REGENCY LAKES
AN ADDITION TO WICHITA, SEDGWICK COUNTY, KANSAS

RE: S/D 96-22, Final Plat of the Regency Lakes Addition

CASE NUMBER: S/D 96-22 REGENCY LAKES ADDITION

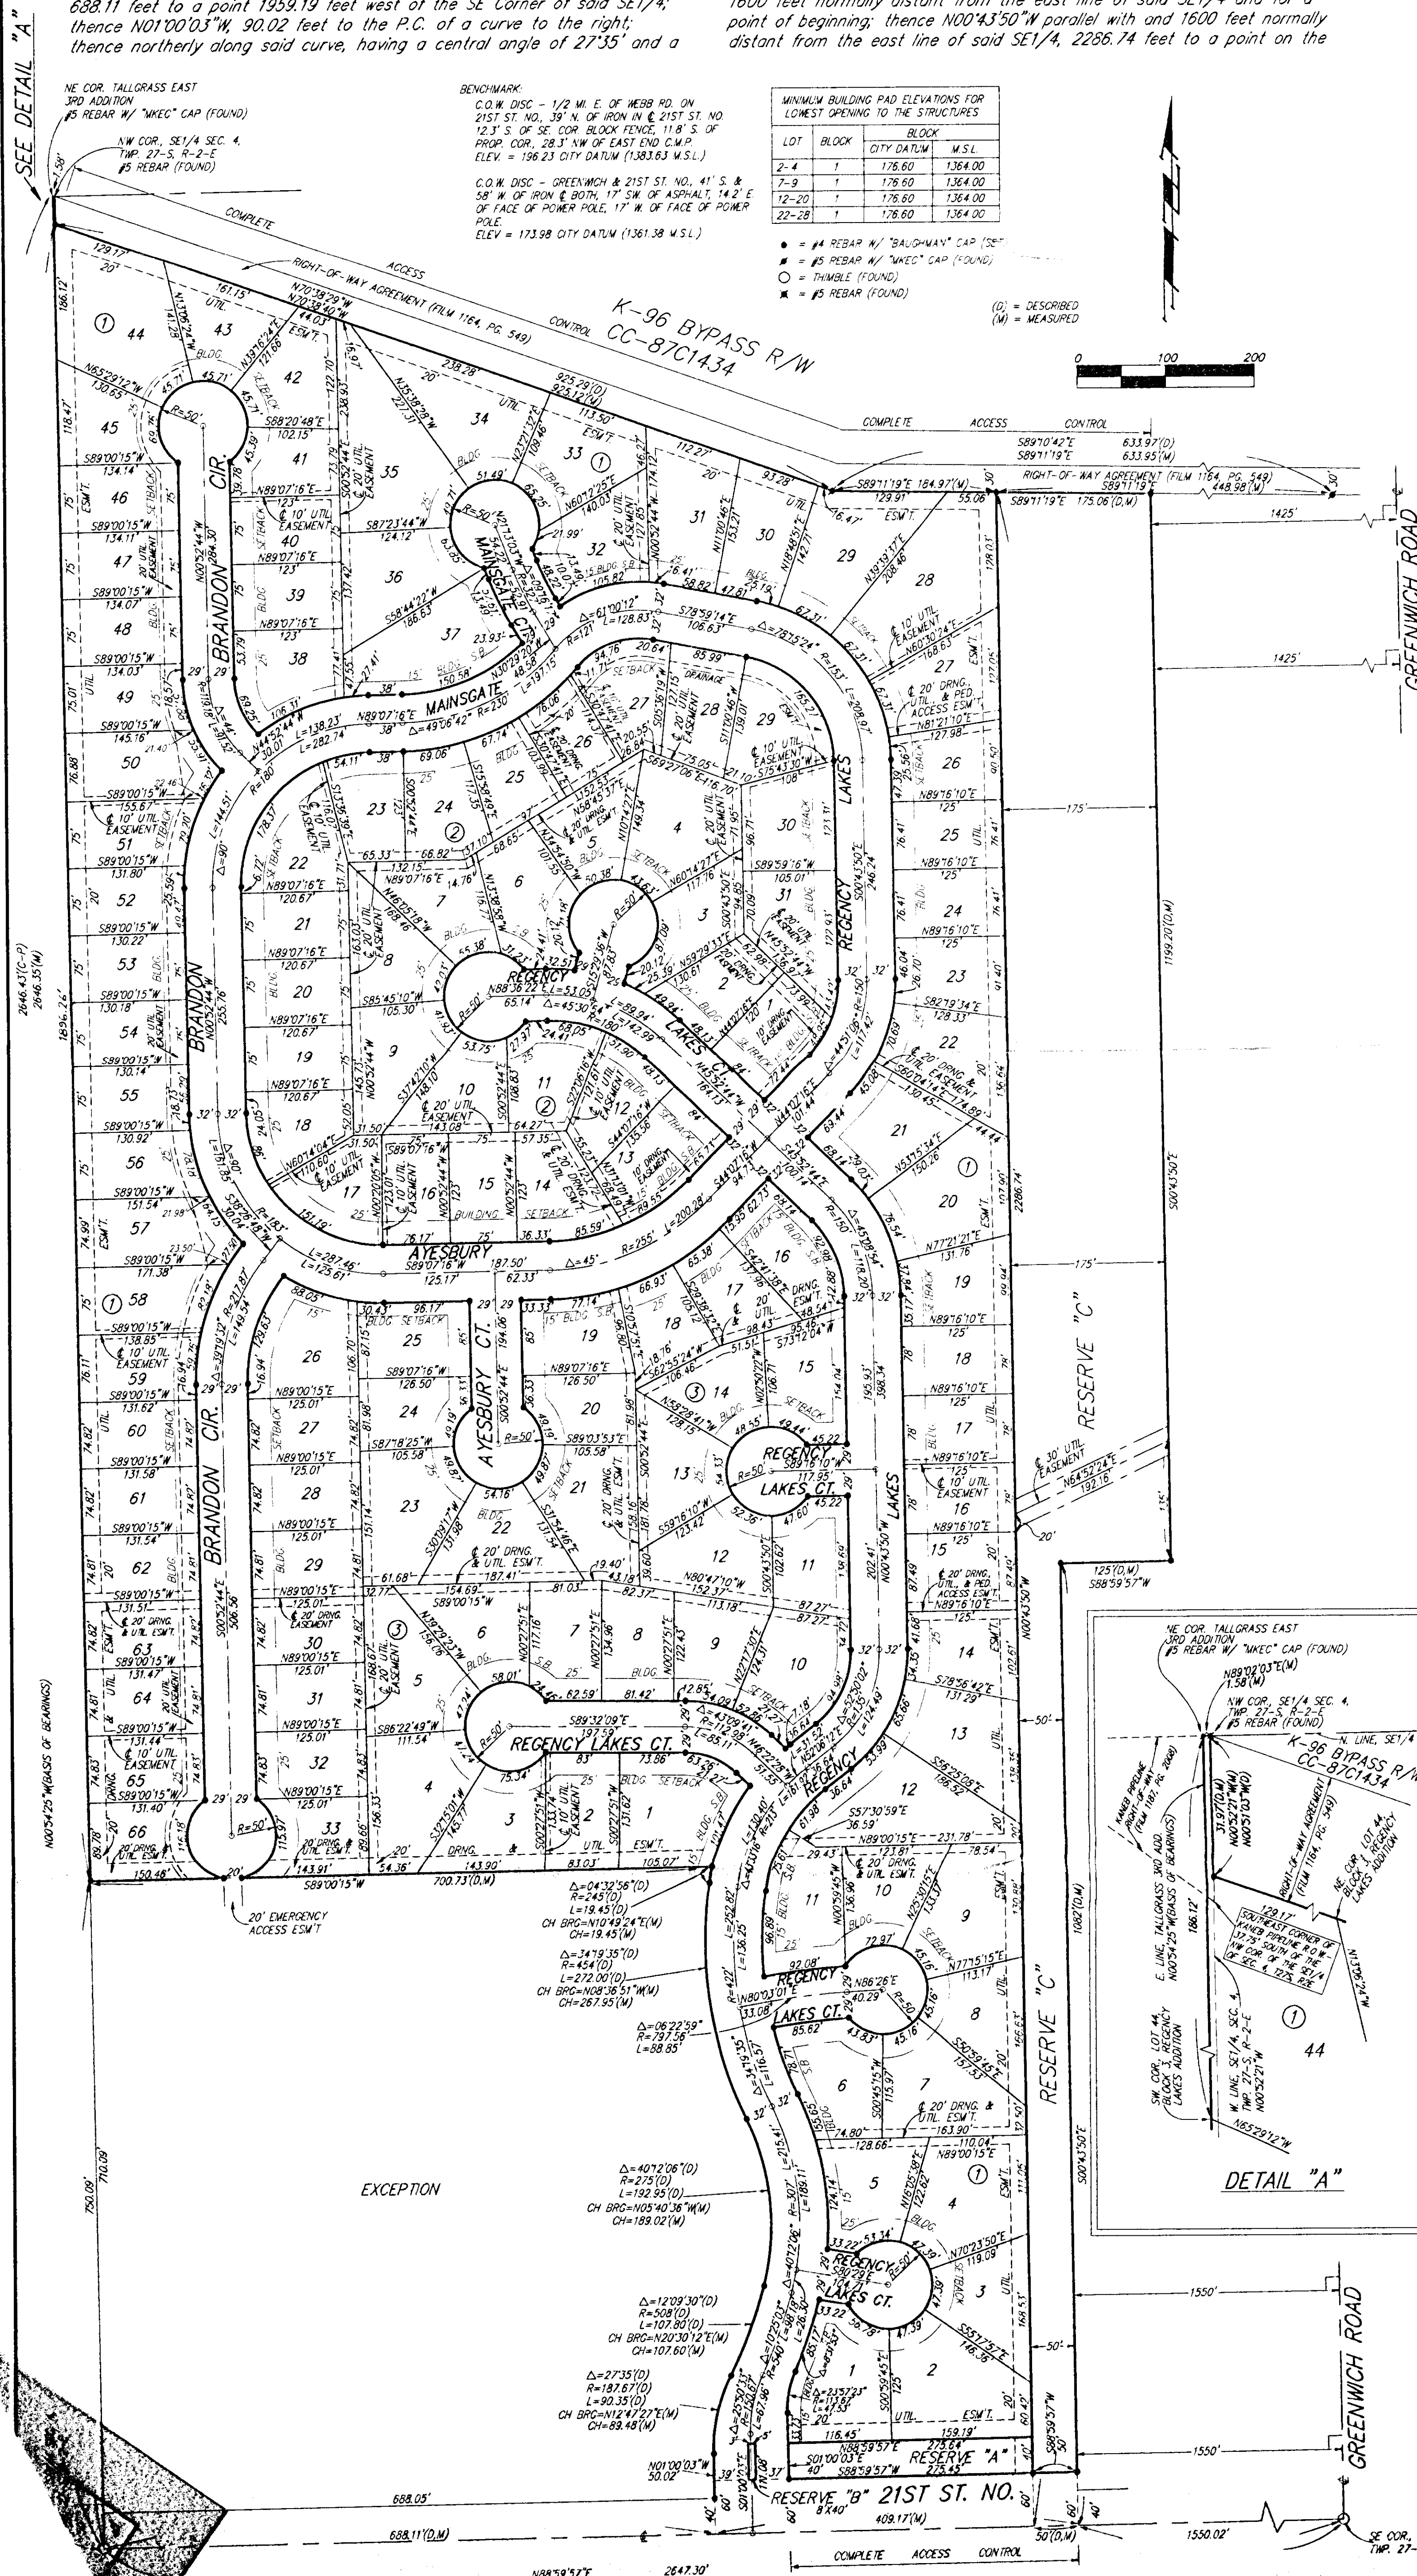
- A. As requested by the applicant, the final plat tracing may include, as a Reserve, the area along this plat's east line. The plat shall note the purpose or uses for this Reserve. Also, at least 2 or 3 means of access shall be provided from this Reserve, westward into the residential areas.

- C. The applicant shall guarantee the extension of sanitary sewer to serve the lots being platted. As noted by Planning and City Engineering, sewer service may not be possible at this time and completion of this plat to the City Council may be subject to the availability of sewer to this site. As needed, off-site utility easements shall be provided for extension of sanitary sewer. *Being provided by Greenwich Street*

- F. As noted by Traffic Engineering, guarantees shall be provided for a left-turn lane in 21st Street and a right-turn lane from the site to serve the development's entrance at 21st Street. *not listed on plat. Phil says this was a dual left turn from site to 21st not an accel along 21st*

G. The applicant shall guarantee any drainage improvements required by the platting of this property. As noted by City Engineering, off-site easements, agreements and improvements will also be required for this site's drainage. In particular, additional computations for the off-site detention facility will be required. A permit from KDOT will also be needed for the drainage involving K-96. Prior to this plat being scheduled for City Council review, a revised drainage plan will need to be approved by City Engineering.

J. Since this site is now indicating only one point of access (Conceptual Plan indicated at least one additional point of access at this plat's northeast corner), for 131 residential lots, with some lots being over 2,000 feet from the site's 21st Street entrance, the applicant shall provide a means of emergency access for this development. Such access needs to be reviewed and approved by the City's Fire Department, with appropriate assurances provided for by the installation and maintenance of any improvements deemed necessary.

N. The applicant is advised that the configuration of Lot 6, Block 2 is somewhat awkward and may significantly hamper the positioning of a home on this lot.

~~X.~~ The final plat tracing shall indicate minimum building pad elevations for lots along the plat's east line, adjacent to the detention facilities.

~~Y.~~ As requested by KG&E-Electric, the final plat tracing shall grant additional, 10-foot utility easements along the following common lot lines: Lots 58 and 59, Block 3, Lots 16 and 17 and 26 and 27, Block 2.
